## Staff Report City of Richmond, Virginia

## Commission of Architectural Review

2. COA-161192-2025	Final Review	Meeting Date: 2/25/2025
Applicant/Petitioner	Erin Webb	
Project Description	Enclose side porch, remove, and replace re	ear porch
Project Location	2905 Patterson Ave	
Address: 500 North Arthur Ashe Blvd	2811 550 500 500 500 500 500 500 500 500 5	
Historic District: Boulevard		
High-Level Details: The property is located at the northwest corner of North Arthur Ashe Boulevard and Kensington Avenue. The residence is a 12,000 square foot, double lot that features a two and a half story single-family Arts and Crafts style house with three detached garages constructed ca 1925.	Boulevard    Solid Control   S	O
The first element encloses the existing side porch with a glazed structure featuring large, clear, insulated glass panels framed by minimal bronze metal mullions and top and bottom rails, positioned inside the existing porch columns. The second element encloses the open terrace between the side porch and the southwest wing with painted wood-frame walls, painted wood windows, and a clear glass roof with standing seam copper. The materials, including Farrow & Ball Matchsti

Figure 1. Existing Photos of Primary Residence:

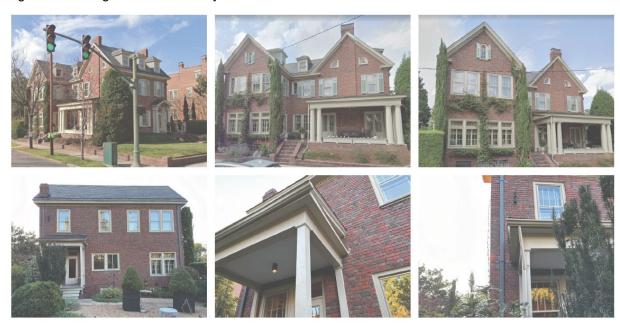
The glass will be installed on the interior side of the existing columns. The character defining features of the porch will not be removed or radically altered.  The guidelines state "do not enclose porches on primary elevations". While this building features two primary elevations (south and east) the side porch is not the primary entrance to the building. The primary entrance is articulated by a front stoop with a portico which faces North Arthur Ashe Boulevard. The applicant is enclosing the side porch in the most unobtrusive way possible, and which can be reversed in the future.  Staff recommends approval of the enclosure of the side porch with the condition that all character defining architectural features such as the columns, entablature, and brick be retained and not altered by the installation of the glass; and that the glass be non-reflective and installed on the interior side of the columns.
